Department of Land Use 1st Exploratory Plan Report

Application Number – 2017-0042-S/Z
Name of Project – Brandywine Country Club
Type of Plan – Major Land Development Plan and Rezoning
Existing Zoning – S – Suburban
Proposed Zoning – ST – Suburban Transition and CR – Commercial Regional
Date of Review – July 12, 2017
Engineer – Christopher Duke, P.E.

Purpose of Plan – Proposed mixed-use residential project and rezoning.

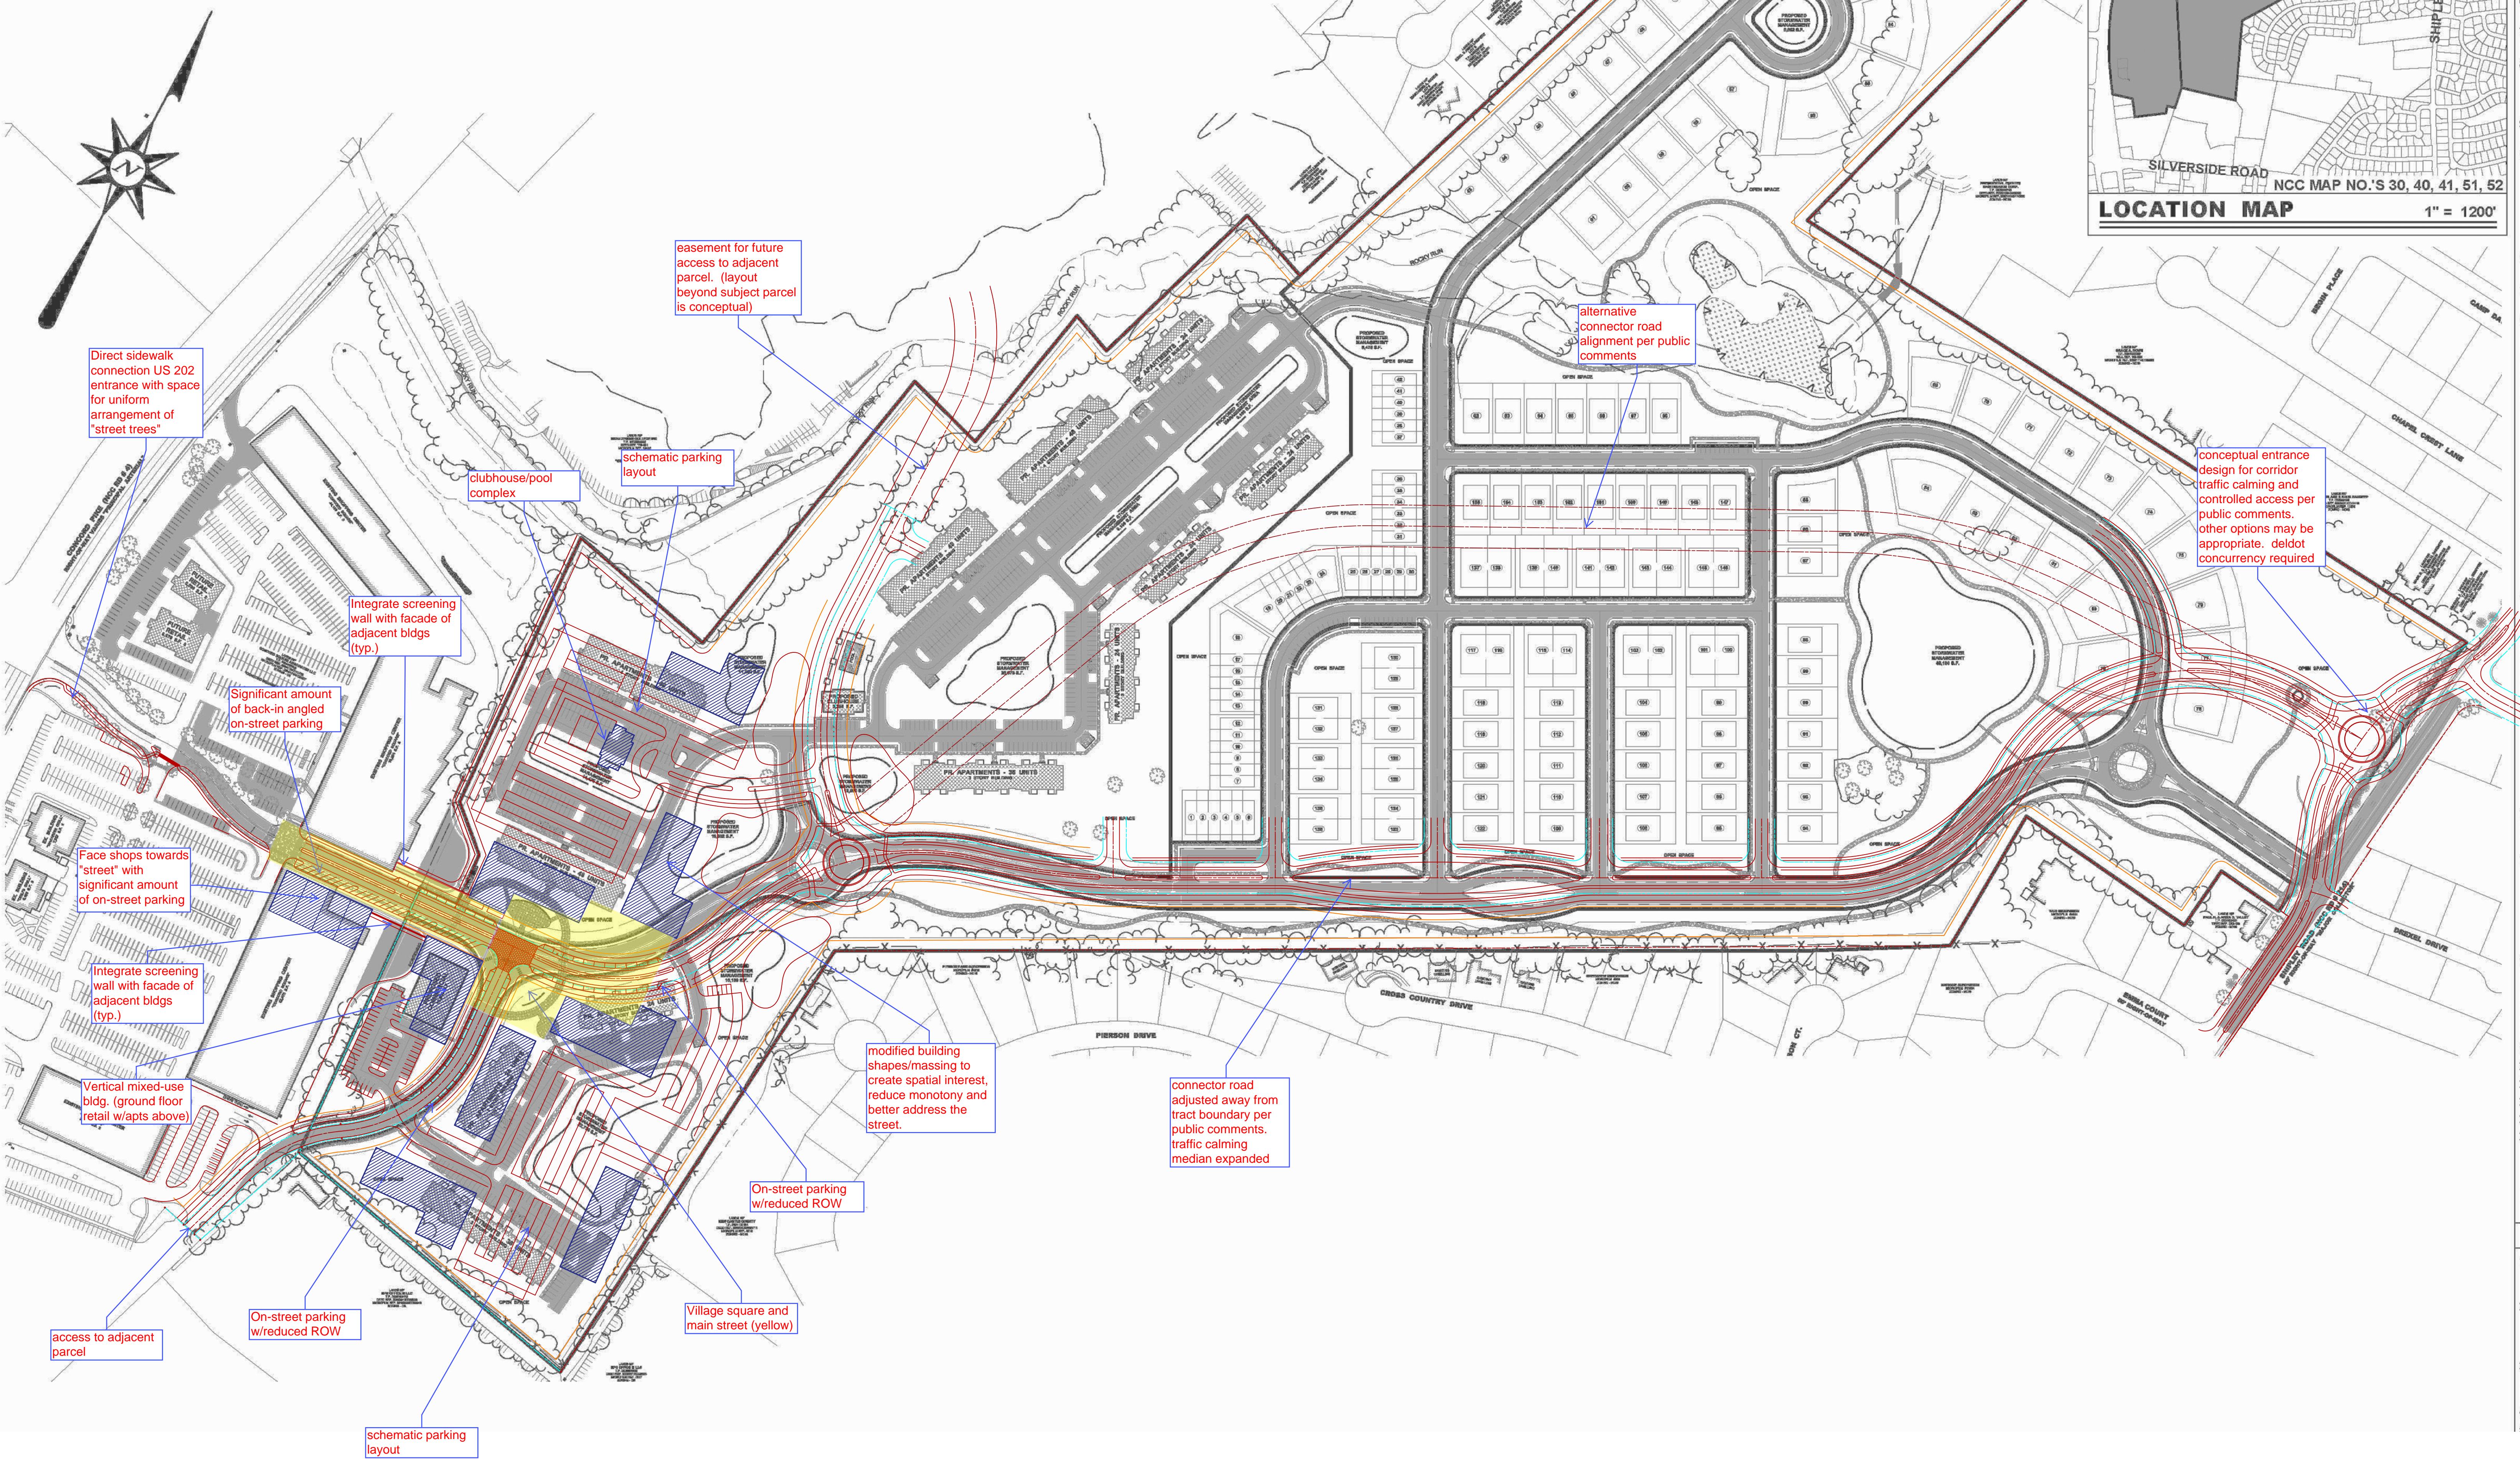
15. Given the public comments received thus far on this application and per initial Departmental review, it is recommended that the following changes to the layout be considered (also please see attached concept sketch):

- A. Provide a significant, physical traffic calming measure for Shipley Road. This may include a roundabout and/or realignment of Shipley Road at the site entrance or some other measure, which would necessitate concurrence from DelDOT. The potential solution should consider the avoidance of ROW impacts to surrounding properties in-so-far as possible;

- B. Adjust the location of the 60' Right-of-Way "Connector Road" along the southern property line with the Greenvue Subdivision such that it is located further away from the rears of neighboring residential parcels. Considerations for berthing and associated drainage, existing tree preservation, and multi-modal access along the southerly property line shall be taken into account. The proposed oval median island for traffic calming proximate to Lots 108 and 122 should be made larger to encompass two blocks for greater usability as open space and to provide a more significant physical presence. Coordinate with DelDOT where necessary;

- C. As an alternative to Item B above, the Connector Road could be located through the center of the subject parcel as a parkway and still provide direct connectivity between Concord Square and Shipley Road. This would necessitate reallocation of proposed residential unit types and, likely, the utilization of alleyways behind certain lots. Smaller lots should be placed along this parkway, with larger lots placed towards the periphery of the subject parcel. Coordinate with DelDOT where necessary;
